**RE:** Carmel Ridge Subdivision  
Grading and Drainage Plan  
Engineer's Stamp Date 3-15-2017 (File: C20D075)

Re: C20D075 Carmel Ridge Subdivision – Grading Plan

CARMEL RIDGE SUBDIVISION

BEING A REPLAT OF LOT 29, BLOCK 3, UNIT 3, TRACT 2, NAA  
GRADING & DRAINAGE PLAN

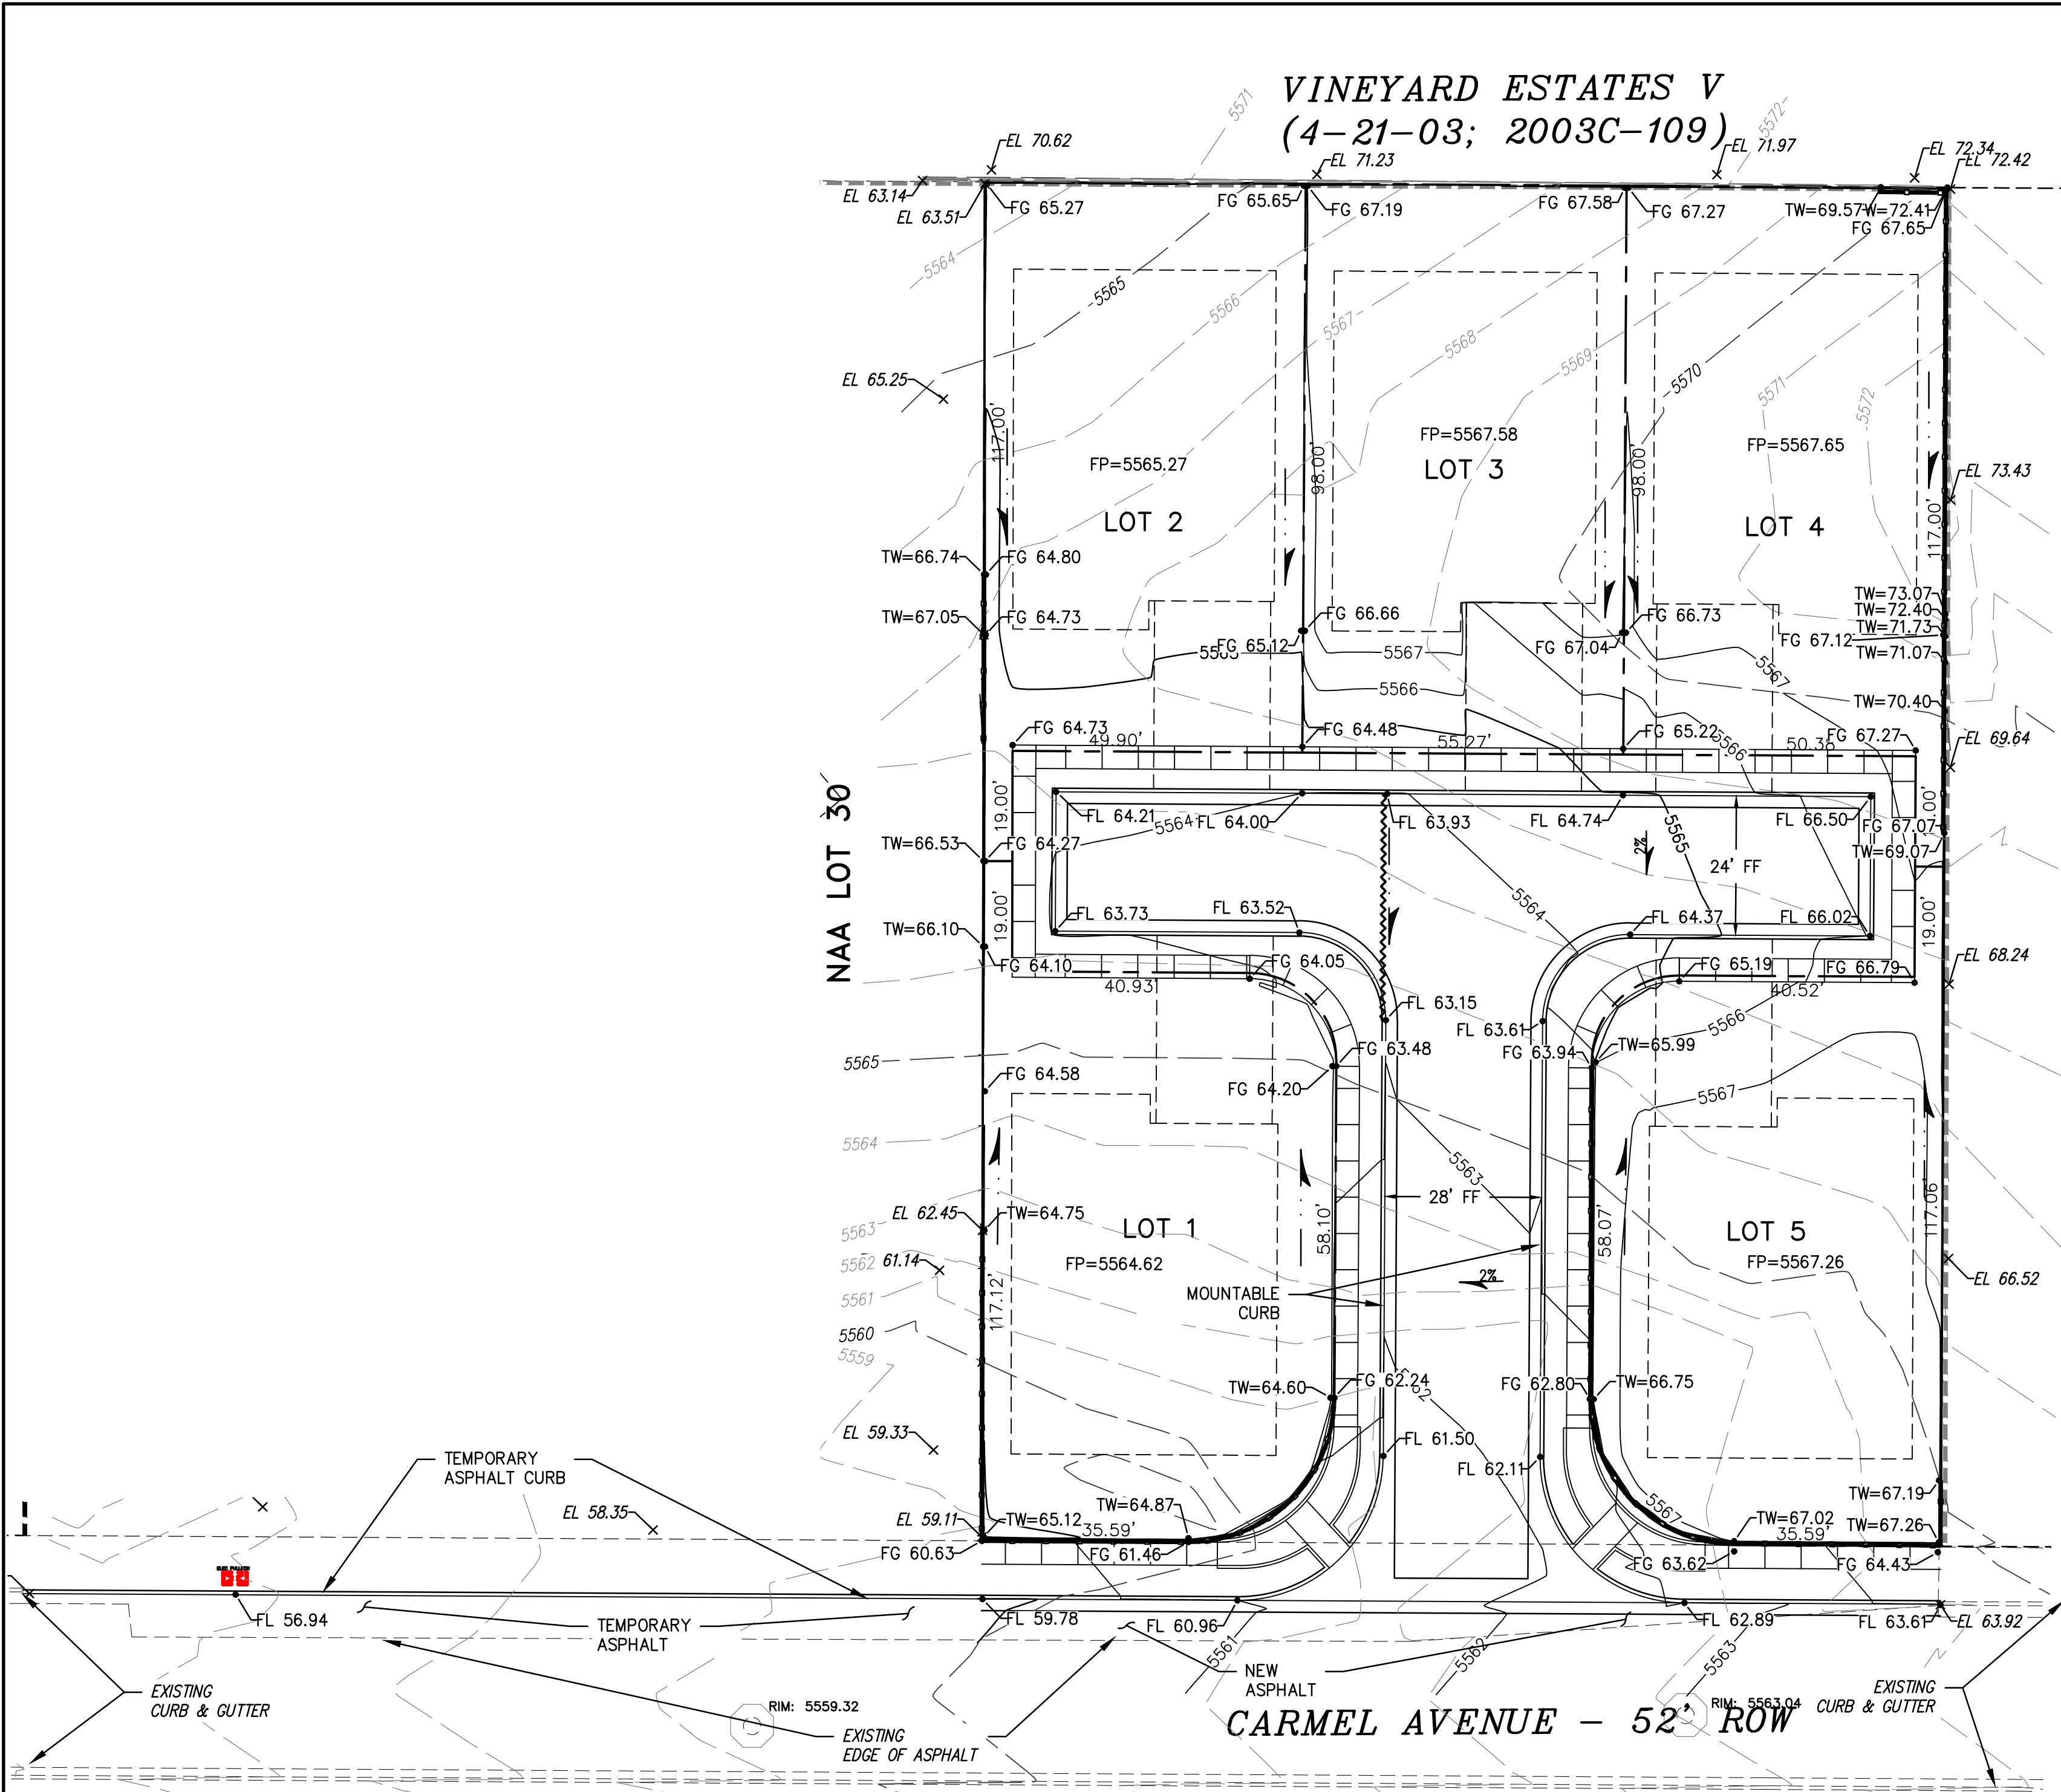
1. The grade of Lot 3 has been changed to closer match existing elevations, and the retaining wall has been extended.
2. Finished grade elevation is indicated
3. The elevations have been verified from flowline of mountable curb to back of sidewalk.
